Meeting Minutes

**Engineering/Minerals
Tonto National Forest
Phoenix, AZ**

Re: Resolution All Things Water Working Group Meeting 1/23/2020

Re: Resolution Copper Mine – Water Resources Workgroup - 1/23/2020

Figure 3.7.2-4. Potential for subsidence lake and other points of exposure of block-cave water

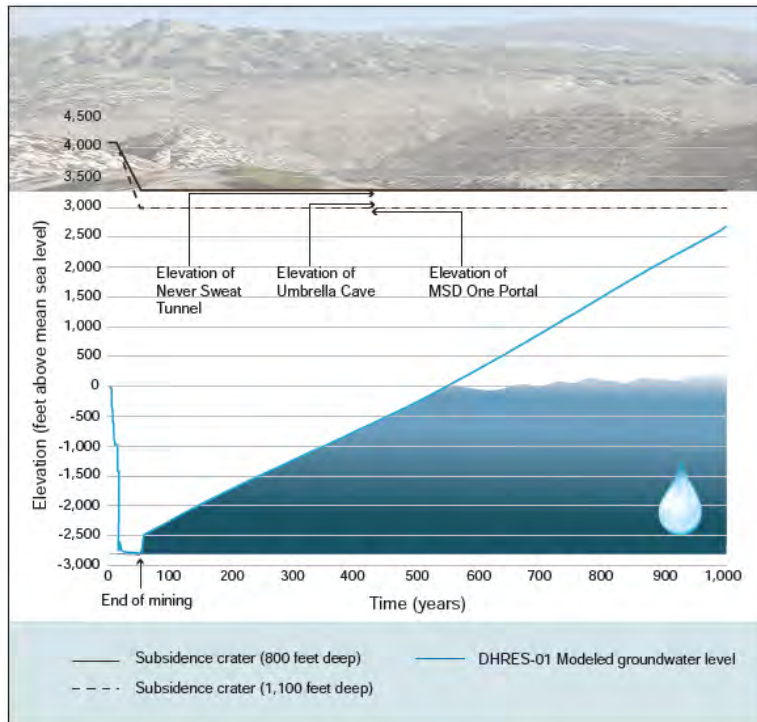
Handout provided includes the rationale used for the DEIS; it was speculative to have a lake form and therefore not included. The graphic and table from handout were included in the DEIS, it shows the levels of anticipated subsidence, water recovery, and exposure pathways. Questions we asked included: How likely is recovering water level to rise to where subsidence drops to? Are there other exposure pathways besides the subsidence crater? The EIS discloses poor water quality in the pit area, but even at 1,000 years there is still 200 feet difference between the deepest sensitivity run for subsidence and the lowest exposure point.

Are there arguments that have been raised which inform a reason to reevaluate our decision?

- Is this model even capable of providing reliable results? WSP noted the hydraulic conductivity was already subjected to 5x the magnitude of the surround rock (100' per day). If you use a number past 100' per day the numerical model no longer matches.

- Could the recovery happen faster? WSP stated this was as far as you can take this model, more importantly the group already decided you shouldn't take the model further than 200 years.

- Was a sensitivity run done to address this? The diagonal line on the graphic shown is the base case.
- Do we know the rock parameters could more water enter to create a lake? Are we creating a "new" type of rock in the fracture zone? Even if a lake occurred in the future the area is regionally a sink. It has been documented and is expected to be bad water quality and there would be impacts. There is long term pump test information from dewatering that show the rock holds water and doesn't let go of it. WSP notes there is not a boundary condition in the model, but a high conductivity high storage unit that is dictated by the surrounding rock. Sources of water feeding into the pit lake included runoff, evaporation, and precipitation. If

there was a 1-foot deep lake, there would be large amounts of evaporation and still below exposure points.

- Jim thinks the timeline should be geologic in nature. Can we better explain the uncertainties and if any extreme cases that far in the future? What if the error bars have a curve that is 10x steeper? Greg says you would need a different model to run enough time for error bars. Could instead add a disclosure that very far in the future and based on lots of uncertainty a lake may eventually form. The value added from considering a lake could inform monitoring in the future. Hugo doesn't think the error bars on the final result preclude you from making a quantitative note. The group had previously considered an open pit then model as it is the material coming into the pit as another option. The model already incorporates high and low sensitivity for subsidence, could add high and low sensitivity modeling for water levels as well to the graphic.

4. The DEIS contains this description of the rationale for why analysis of a crater lake is speculative (DEIS, p. 375-376, provided in its entirety below).
 - Do the comments (including the Prucha report) provide new information, analysis, or reasoning that would change this rationale?
